July 9, 1982  
SBN-290  
T. F. B 7.1.2

Subject: Response to 810 Series RAI's; (Emergency Preparedness Licensing  
Branch)

# Attachment A

TABLE 4.3

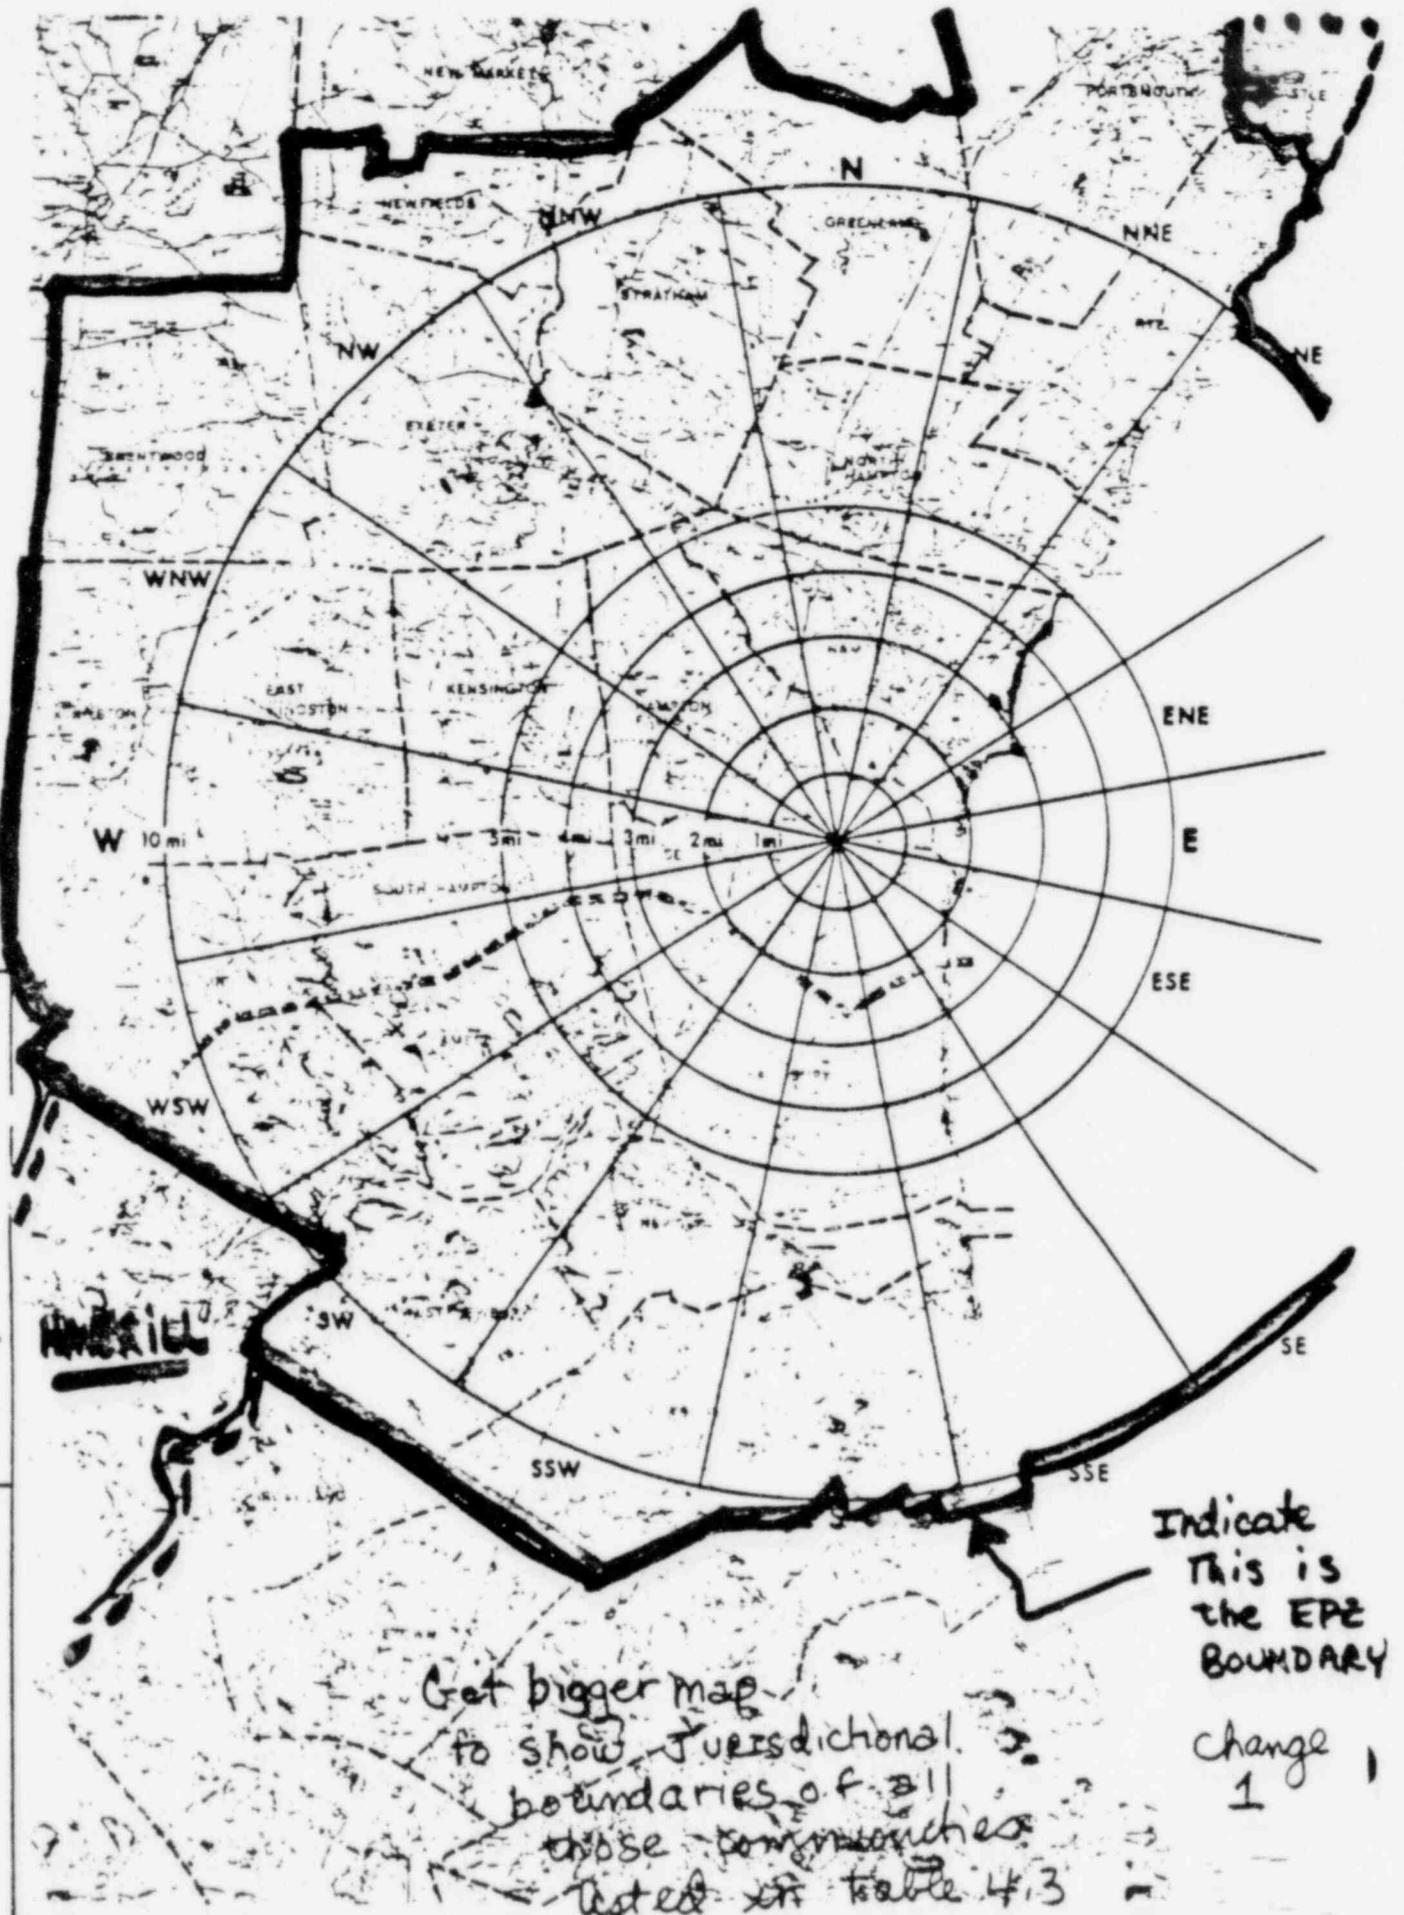
810.4 Adjust the plume EPZ boundary to account for local response needs and capabilities in accordance with 10CFR50.33. In addition, discuss how demography, topography, land characteristics, access roads, and jurisdictional boundaries were considered.

Insert changes  
as specified for  
Change 1

RESPONSE: The Seabrook Station plume EPZ has been determined strictly on the basis of jurisdictional boundaries. Section 4.3, Table 4.3 of the Seabrook Station Emergency Plan identifies a list of local communities whose jurisdictional boundaries have been determined by State authorities to define the Seabrook Station plume EPZ. Seabrook Station recognizes that this plume EPZ designation is subject to future change dependent upon final agreements reached with these communities.

This item is addressed by revisions to Table 4.3 and Figure 4.7 of the Emergency Plan.

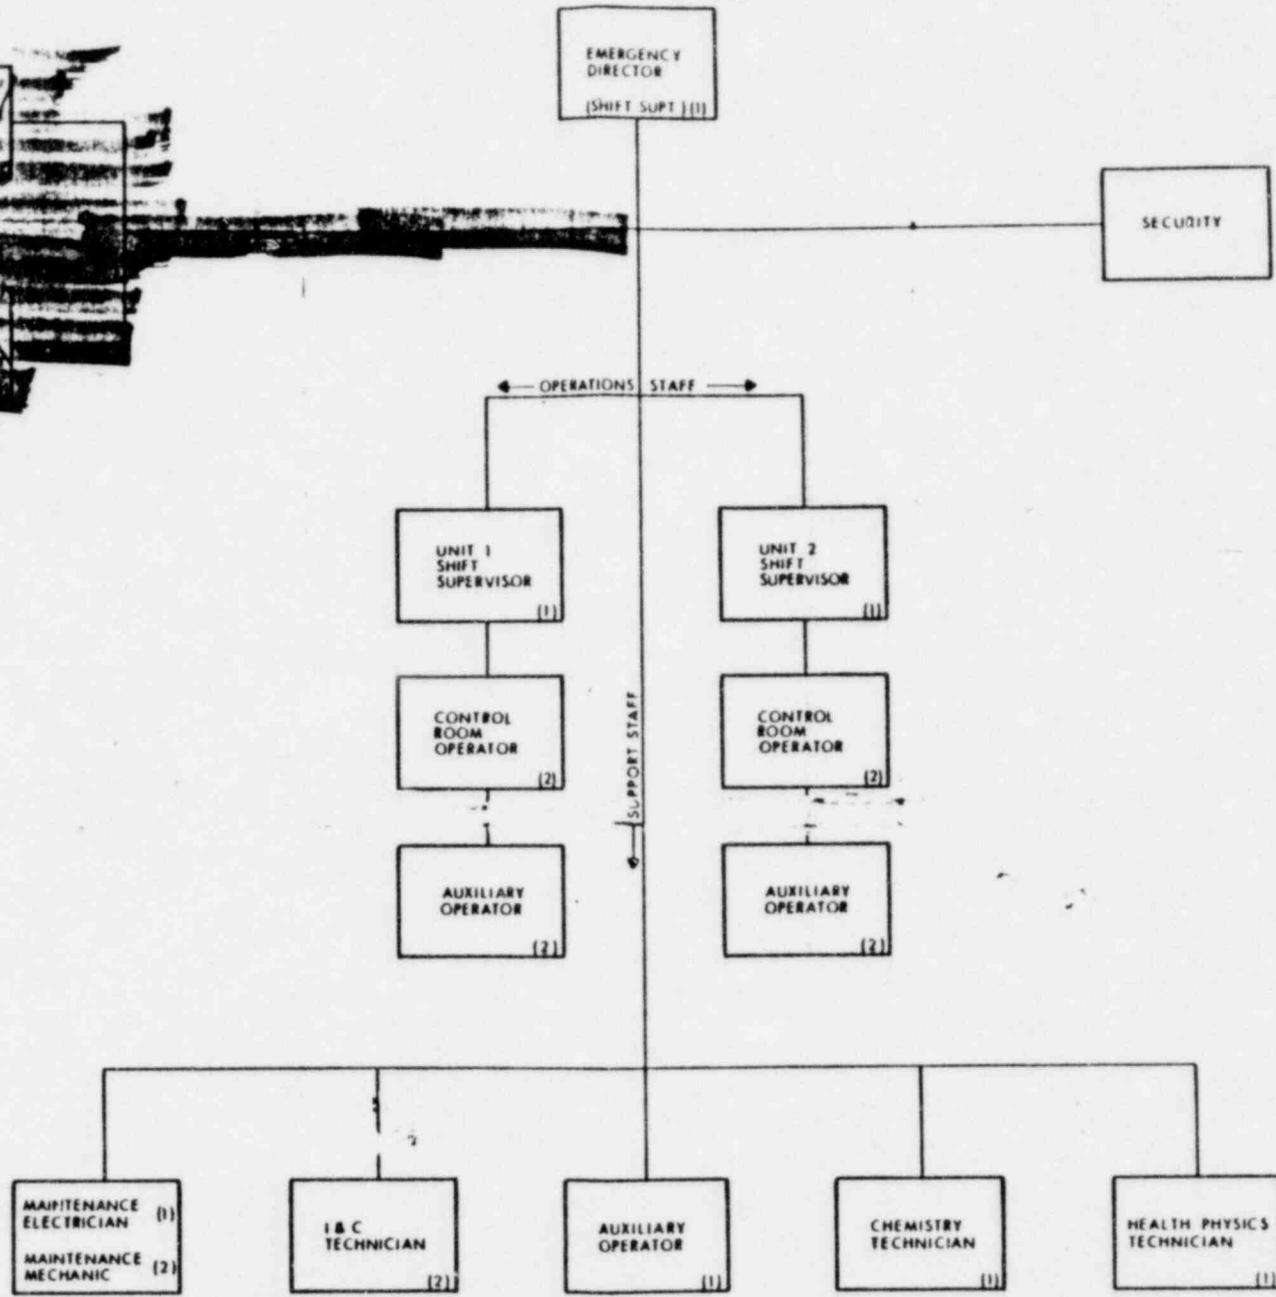
Delete this information and insert change 4

delete  
as  
indicated  
by  
change 4
